**F D RICHARDSON HEIGHTS SUBDIVISION,**  
**RESUBDIVISION OF LOTS 1, 16 THROUGH 20 &**  
**COMMON AREA**

APPLICATION NUMBER 1 DATE May 20, 2010

# DETAIL SITE PLAN

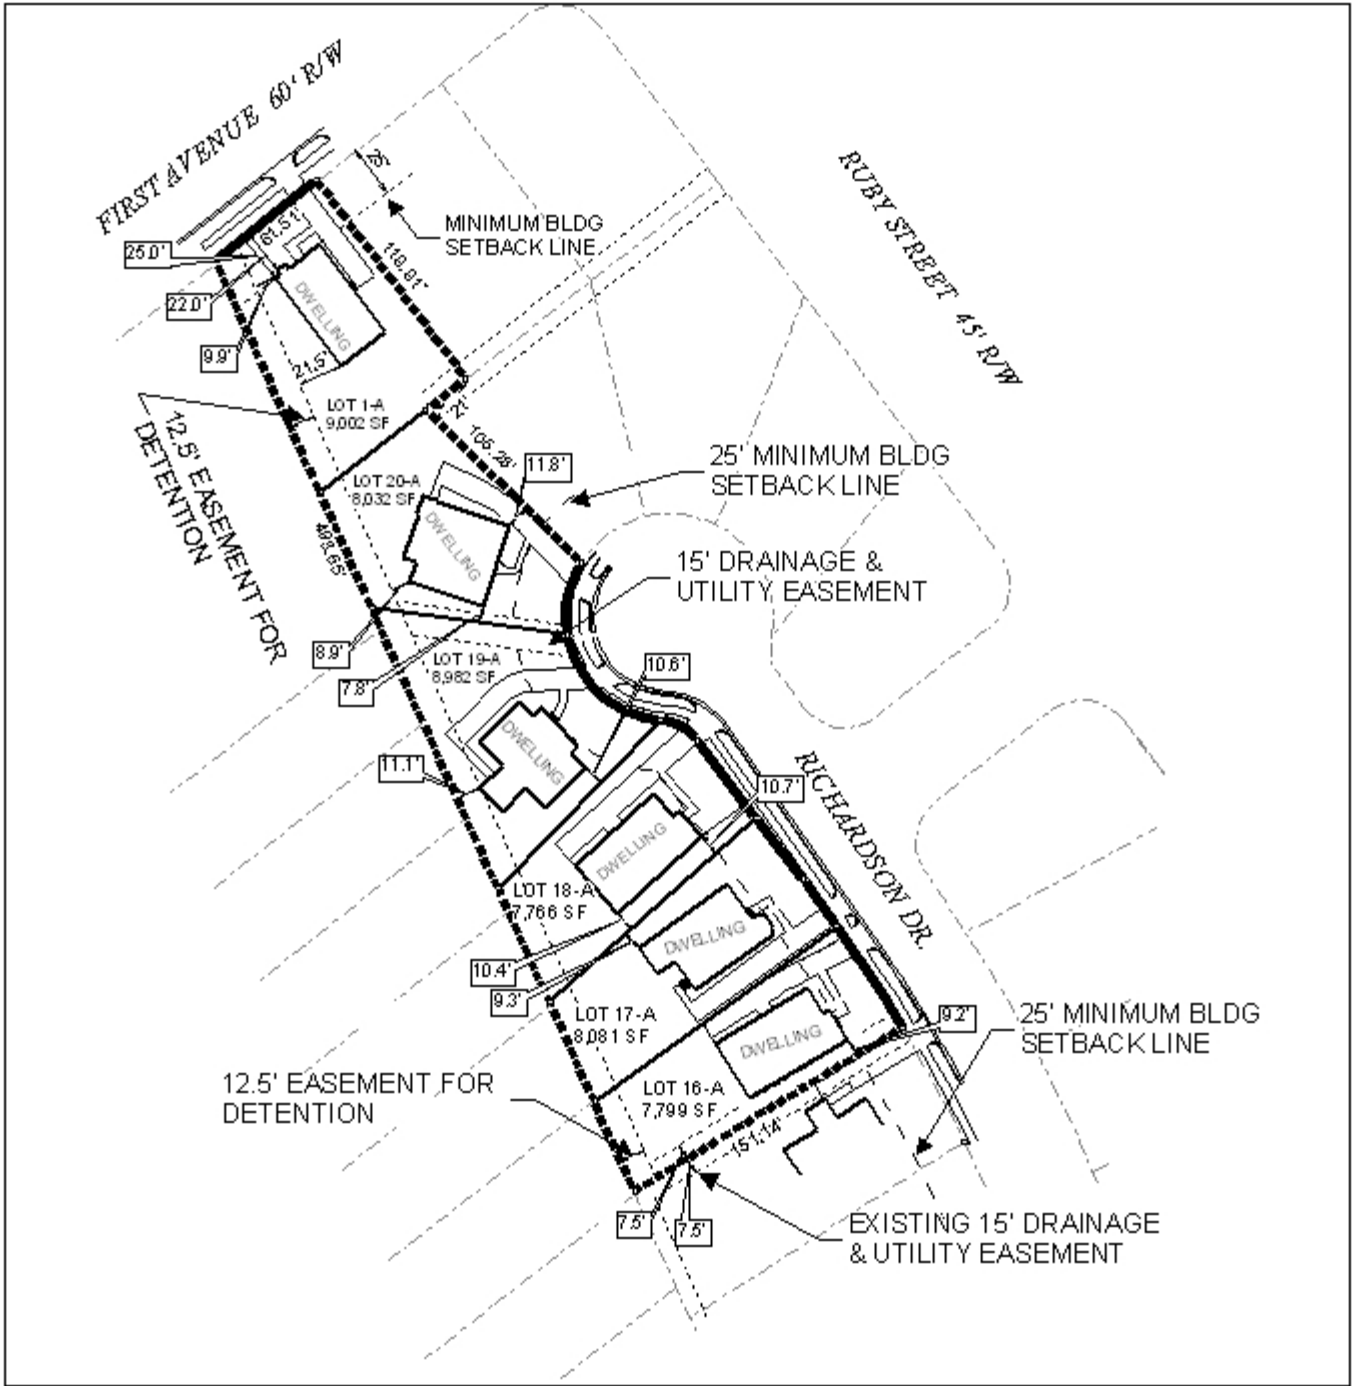
With that said, it should also be noted that there are several storage sheds on several of the properties, not shown on the plat, and that one house partially encroaches in to the common area / proposed easement with an apparently unpermitted addition. If approved, the applicant should revise the plat to illustrate all improvements within the subdivision, with the obtainment of all necessary permits from the Permitting Section of Urban Development.

- 1) *placement of a note on the final plat stating that no construction is allowed within any easements;*
- 2) *retaining of a note stating that each lot is limited to one curb cut each with the size, location, and design to be approved by Traffic Engineering and in conformance with AASHTO standards;*

- 3) *revision of the plat to illustrate ALL improvements within the subdivision, with the obtainment of ALL necessary permits from the Permitting Section of Urban Development prior to signing the final plat; and*
